Docket No. 50-443
Docket No. 72-63
SBK-L-22040

Seabrook Station Radiological Emergency Plan (SSREP), Revision 78

Enclosure 1 to SBK-L-22040
Summary of Changes

Enclosure 2 to SBK-L-22040
Change Analysis Summary

FIGURE 8.2

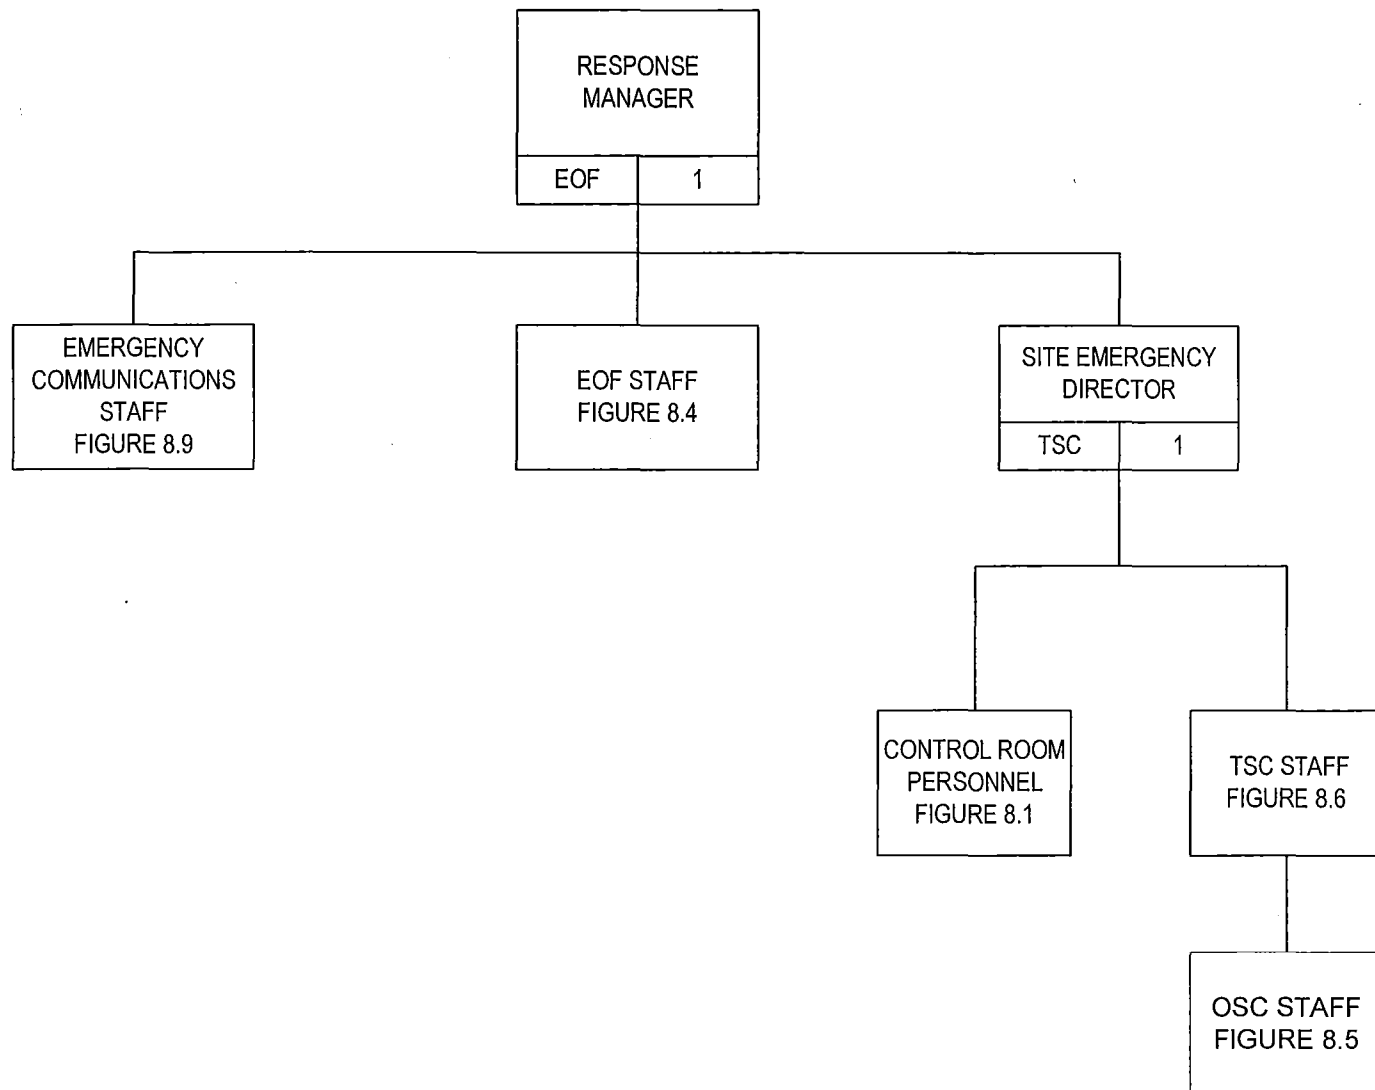
- Section 7.5.2 – Removed reference to the Health Physics (HP) Alternate Checkpoint radio console.
- Figure 8.2 – Replaced SNC (Science and Nature Center) with JIC (Joint Information Center).

The Science and Nature Center was replaced by the Joint Information Center in SSREP Revision 77, however “SNC” remained in Figure 8.2.

Figure 8.2 – Replaced SNC (Science and Nature Center) with JIC (Joint Information Center).
